Device **TC22x/TC21x**
Marking/Step **ES-AC, AC**
Package **see Data Sheet**

10208AERRA

This Errata Sheet describes the deviations from the current user documentation.

Figure 1 Example sequence showing how registers ETRRx may be filled with “Error Free” addresses

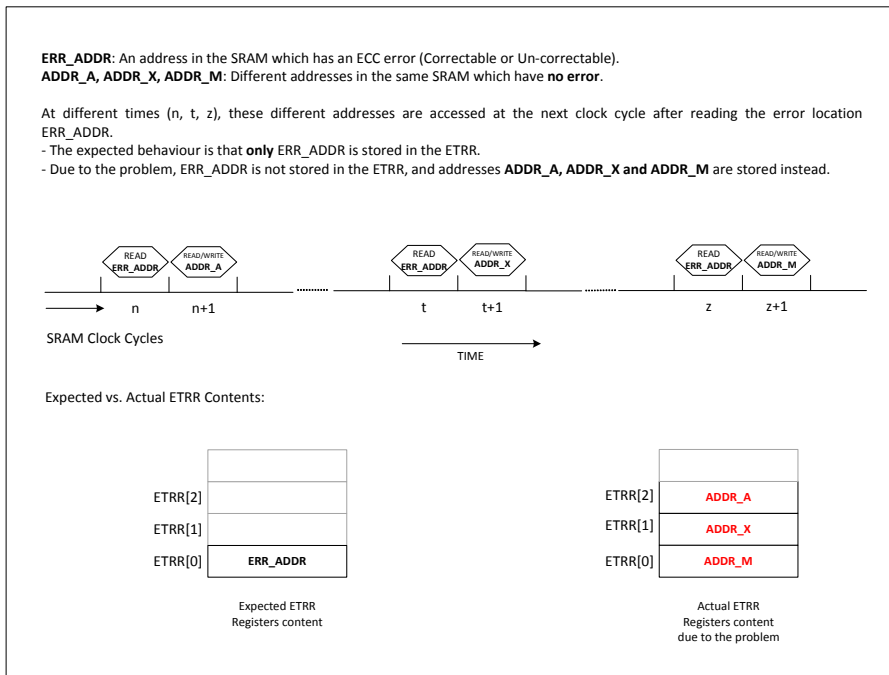
When such a consecutive access sequence (read from ERR_ADDR followed by read/write of different address(es)) happens multiple times, registers ETRRx

are filled with addresses that have actually no error – and the SRAM address which actually has an error is not stored indeed. **Figure 1** shows such an example scenario.

The consequence of the scenario explained in **Figure 1** is that a single error in the SRAM – example just one correctable error at a location ERR_ADDR – can result in registers ETRRx getting filled with fault-free address, and thus potentially even triggering an ETRR overflow.

2. Depending on the access sequences, an ETRR overflow might be triggered with one real error (e.g. correctable error) in the SRAM – consequence of the example shown in [Figure 1](#).

Figure 2 Recommended Software Handling - Flowchart

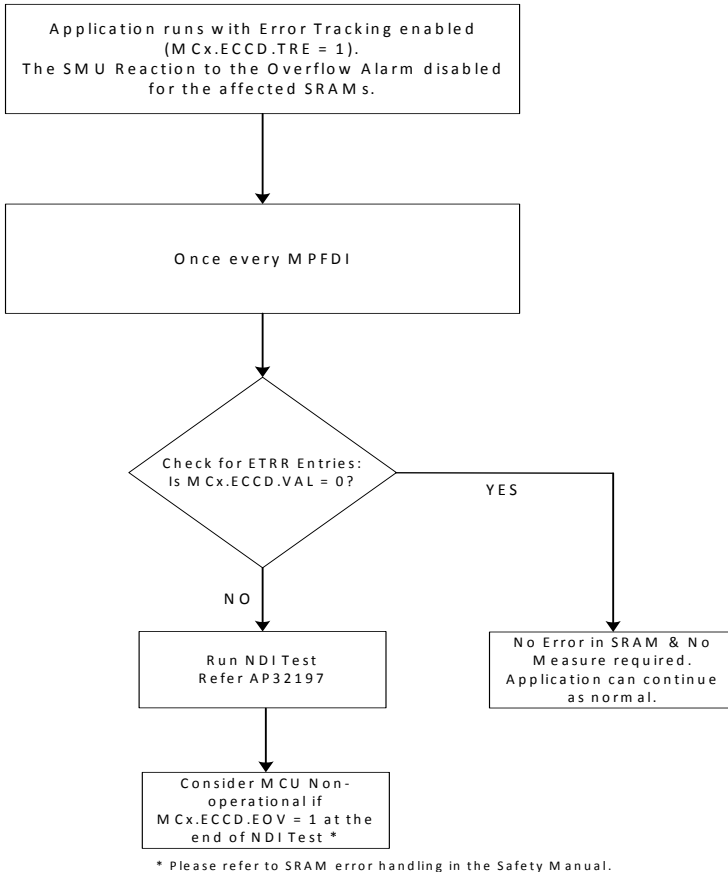
A flowchart of the recommended software handling is shown in [Figure 2](#).

If there is at least one valid ETRR entry (i.e. $MCx.ECCD.VAL \neq 0$) then the software shall run a Non-Destructive-Inversion (NDI) Test on the affected SRAM. Please refer to application note AP32197 (AURIX™ Memory tests using the MTU) for an example regarding running this test.

At the end of this test, if an ETRR overflow is detected ($MCx.ECCD.EOV = 1_B$) then the MCU shall be considered non-operational. Refer to section on Correctable SRAM Error handling in the Safety Manual.

Figure 3 Register GxVFR in the VADC Module of TC2xx Devices

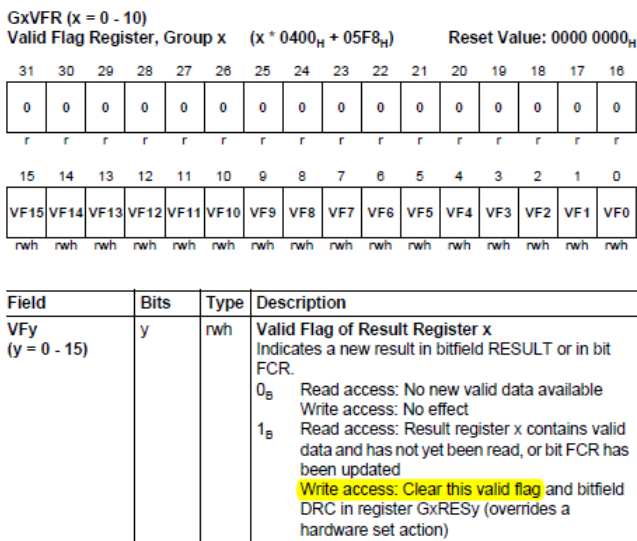
Example: Consider the GxVFR register in the VADC module:

The bits in the GxVFR register have to be written with 1_B to clear a valid flag VFy indicating a valid result. Assuming VFy = 1_B, if one of the RMW instructions listed above is used, the write to VFy would never happen since VFy is already set to 1_B. This means that the next read of VFy may lead to incorrect conclusions by software.

Figure 8 Ripple Voltage vs. Frequency Characteristic

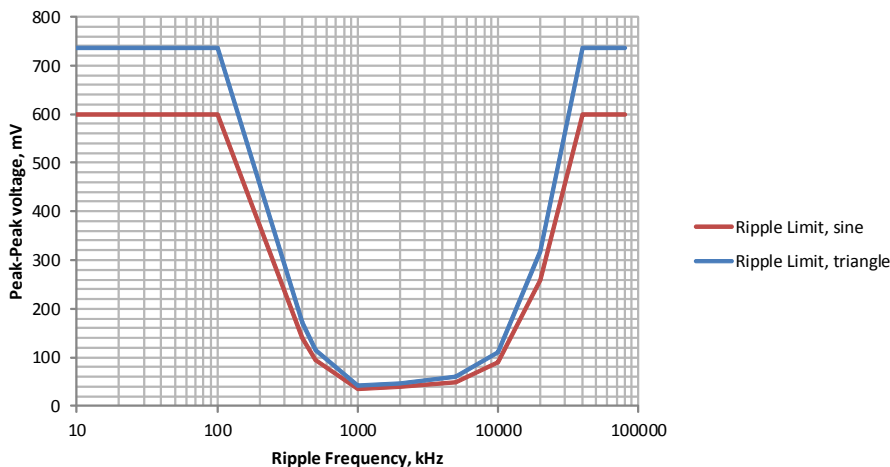
improper behavior of the start-up scheme of the back-up clock, and thus stuck-at state during the start-up of the microcontroller until this condition is removed.

The acceptable voltage vs. frequency characteristic is portrayed below on the chart:

The diagram reflects acceptable ripple level during the cold start of the microcontroller at the respective VDDP3/VEXT/VEVRSB supply of the PMS subsystem, depending on the device and package type, as shown in the following table.

Apply an additional ceramic capacitor at the respective VDDP3/VEXT/VEVRSB supply input (at pins specified above) to attenuate the residual ripple of the buck converter. The resonant frequency of the additional filter capacitor shall be chosen in accordance with the amplitude-frequency characteristic given above and the switching frequency of the DC-DC converter in order to provide a proper attenuation in the range of interest.

Figure 9 Short Serial Message, Serial Data Encoding over 16 messages

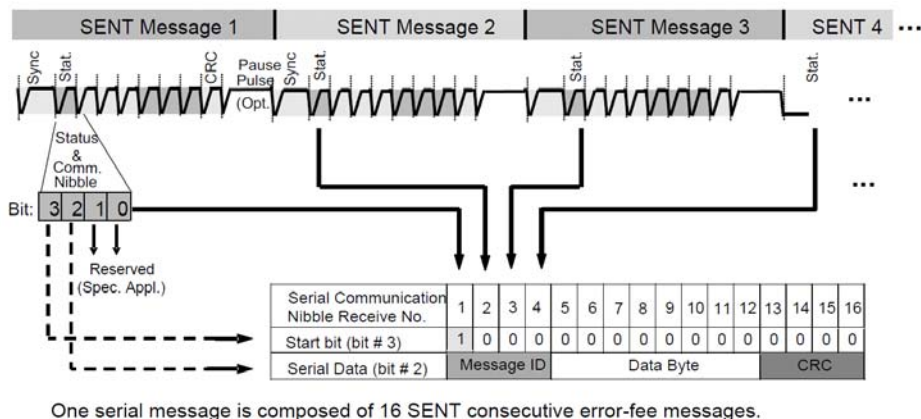
This is not always correct under all circumstances:

Figure 9 shows a corrected version of this figure.
